City of Portland, Maine – Building or Use Permit Application 389 Congress Street, 04101, Tel: (207) 874-8703, FAX: 874-8716

Location of Construction: 44 Maple St., Peaks Island		Owner: Bragdon, Fred & Margaret		Phone:		Permit No: 981212	
Owner Address: SAA 04108		Lessee/Buyer's Name:		Phone:		BusinessName:	
Contractor Name: ***** John Kielgy		Address: 591 Island Ave Peaks Island, ME		Phone: 04108 766-2026		<div style="border: 2px solid black; padding: 5px; text-align: center;"> PERMIT ISSUED Permit Issued: OCT 26 1998 CITY OF PORTLAND </div>	
Past Use: 1-fam		Proposed Use:		COST OF WORK: \$ 5,000.00		PERMIT FEE: \$ 45.00	
				FIRE DEPT. <input type="checkbox"/> Approved <input type="checkbox"/> Denied		INSPECTION: Use Group: Type:	
				Signature:		Signature:	
Proposed Project Description: Amend Permit #981157 Revised roofline & new roofline for rear entry				PEDESTRIAN ACTIVITIES DISTRICT (P.A.D.) Action: Approved <input type="checkbox"/> Approved with Conditions: <input type="checkbox"/> Denied <input type="checkbox"/> Signature: Date:

AMMENDMENT FOR PERMIT # 981157

BUILDING PERMIT REPORT

Roof Layout

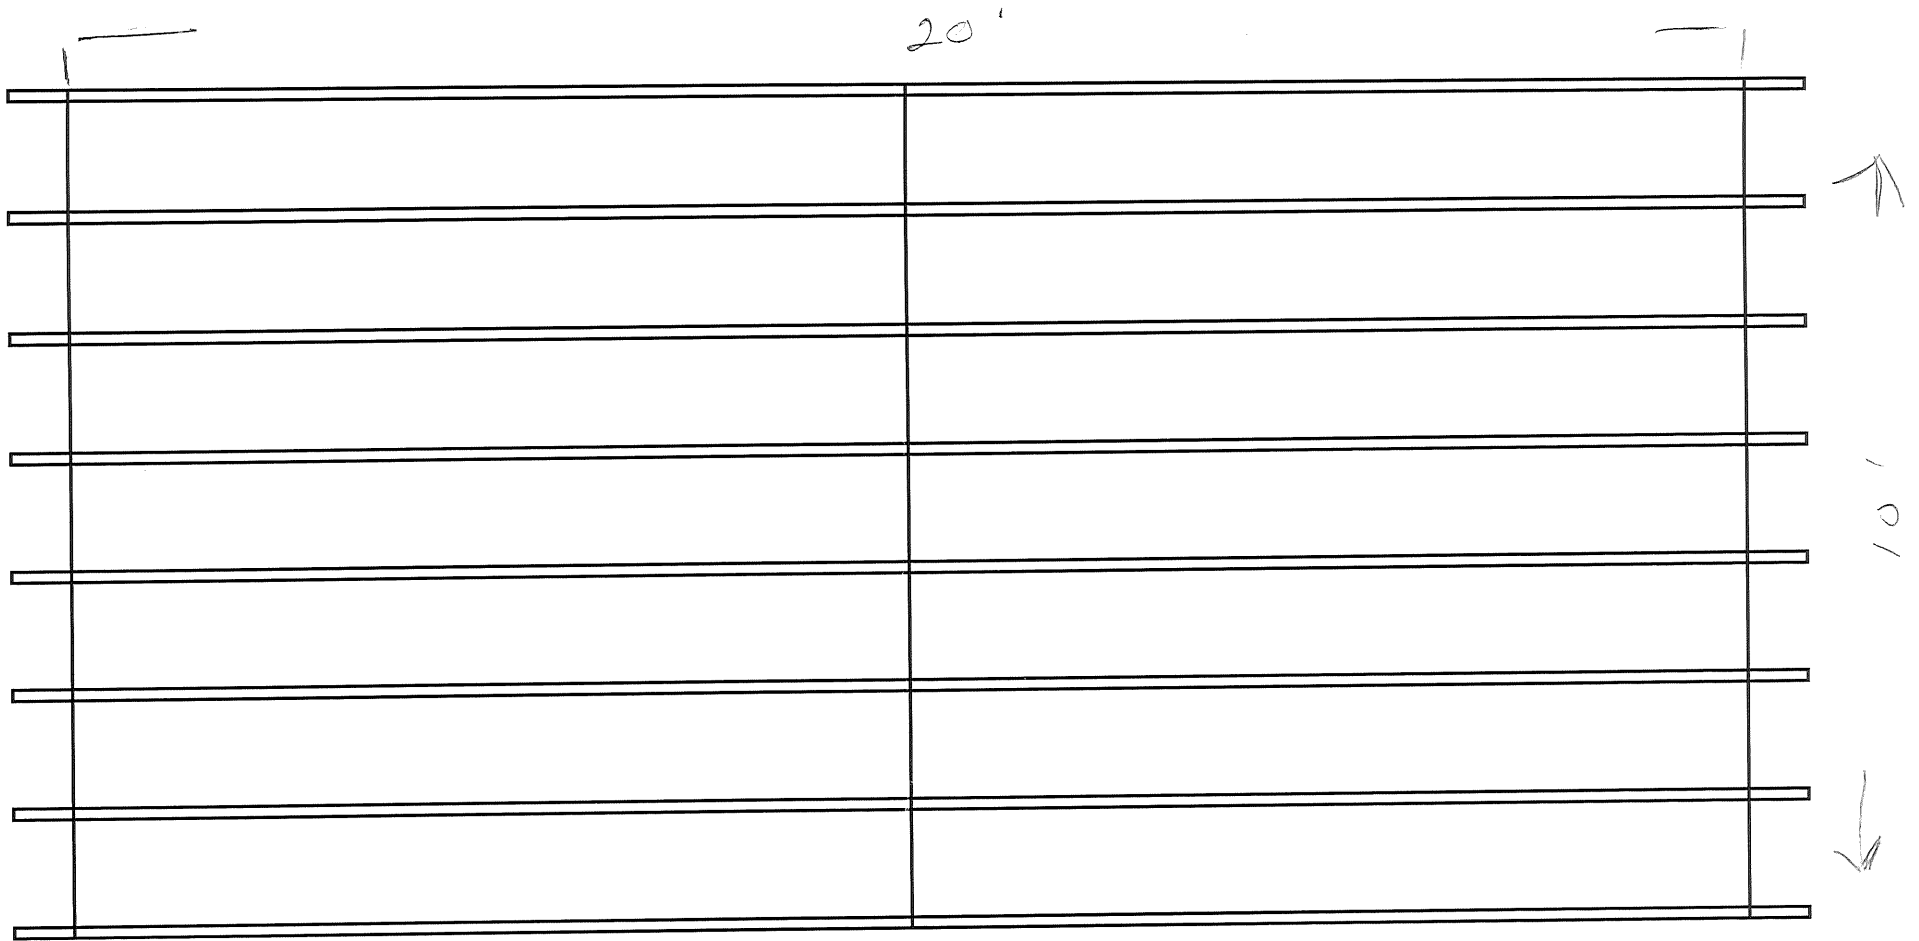
30. Glass and glazing shall meet the requirements of Chapter 24 of the building code.
- * 31. Your submitted plan did not show the micro lams Joist size - Please submit this info. before work is started -

PROJECT	COMP. BY	JOB NO.	PROJECT	COMP. BY	JOB NO.
	CHK. BY	DATE	Bragdon's House upstair west end	CHK. BY	DATE

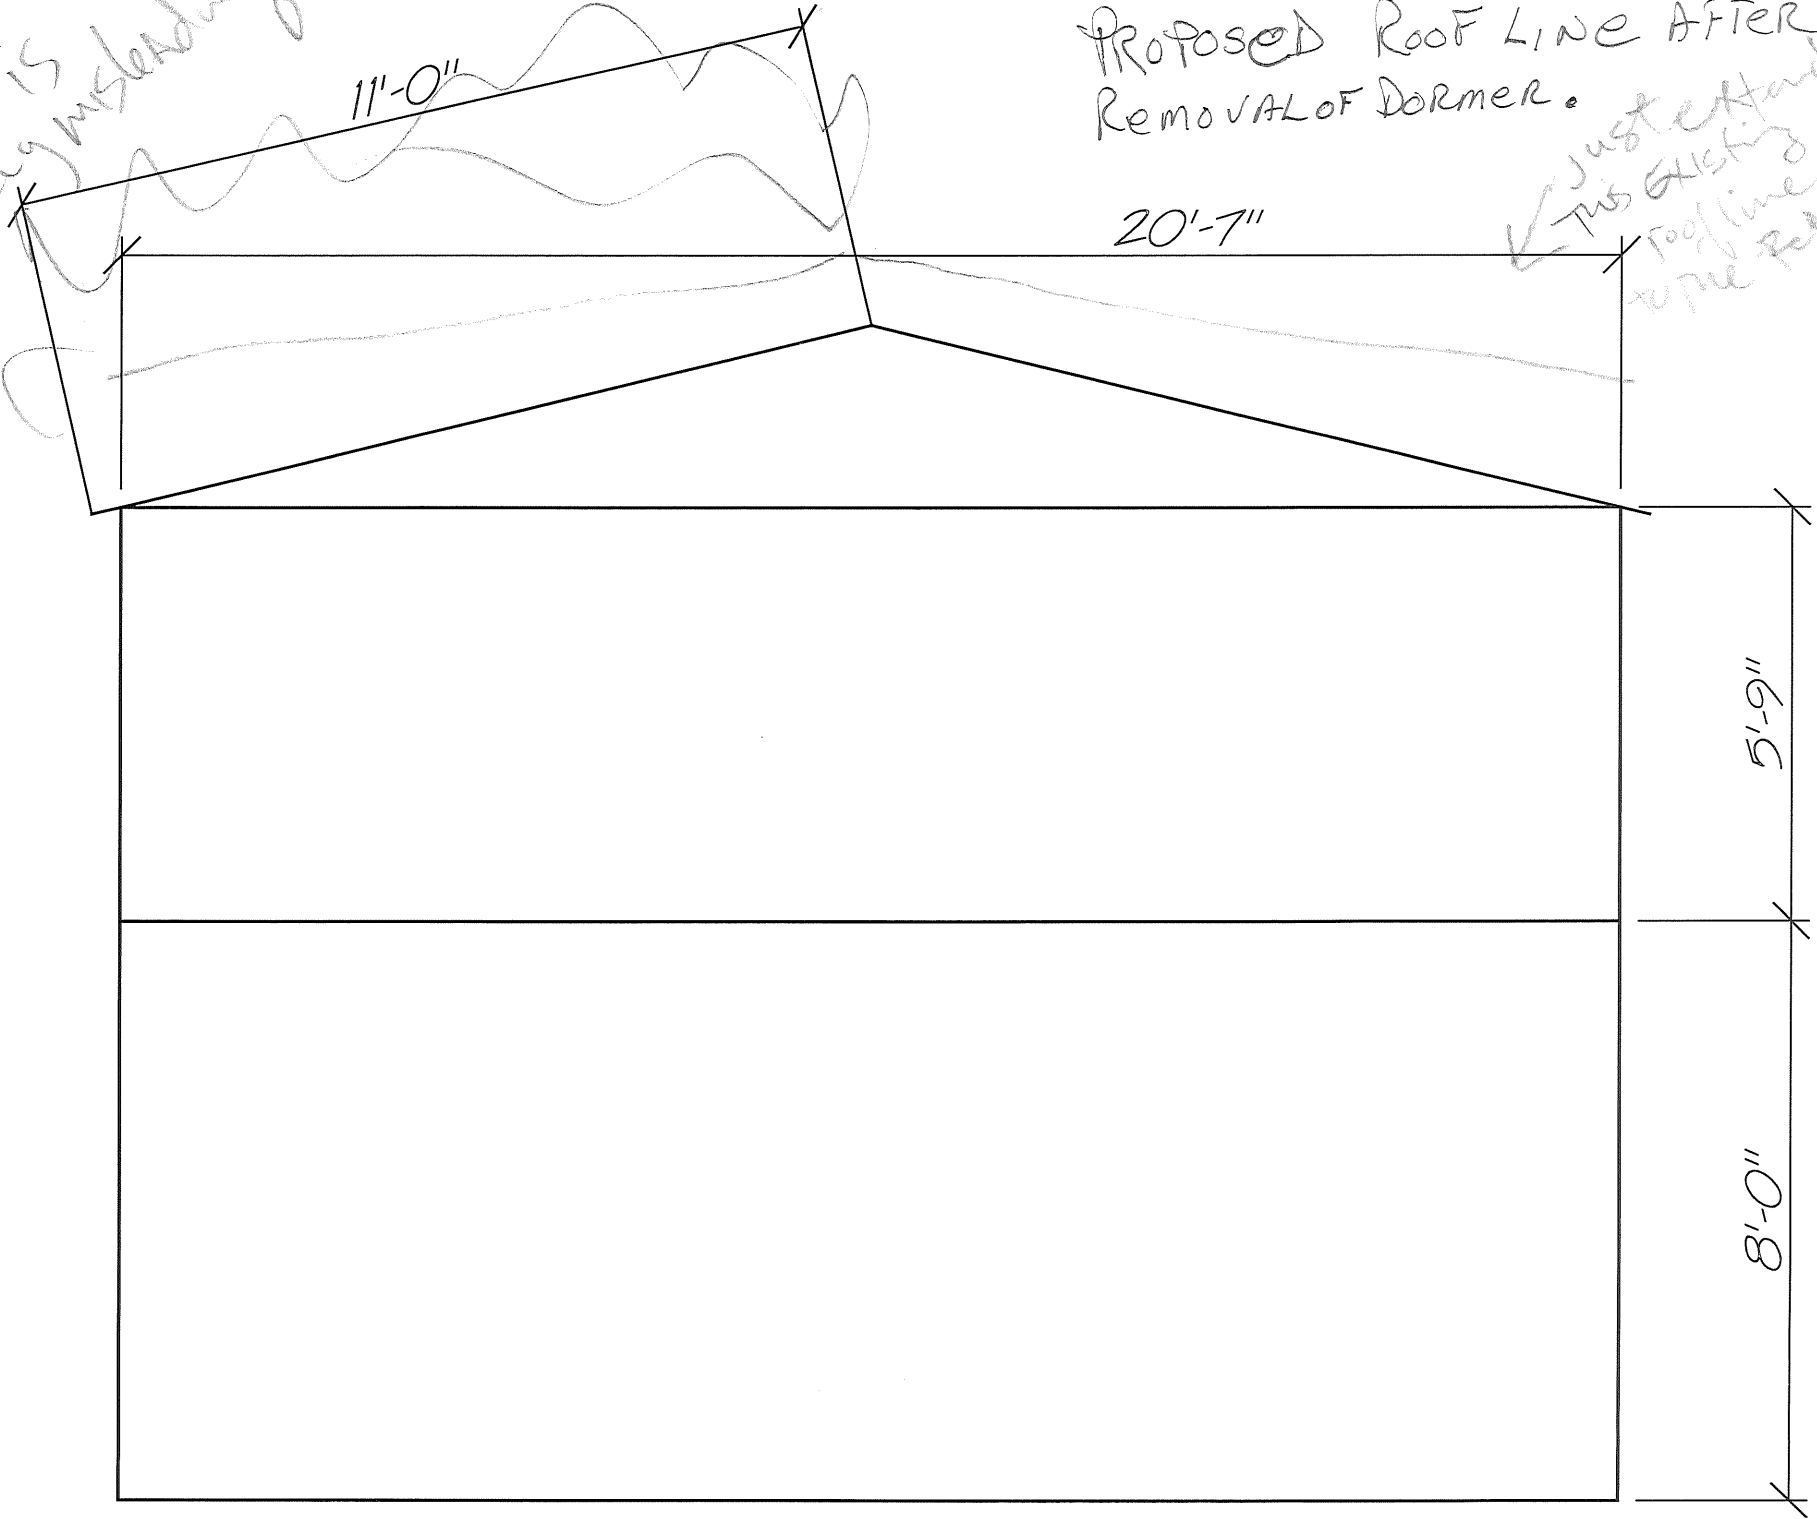
This is
totally misleading

Just extend
this existing
roof line
to the peak
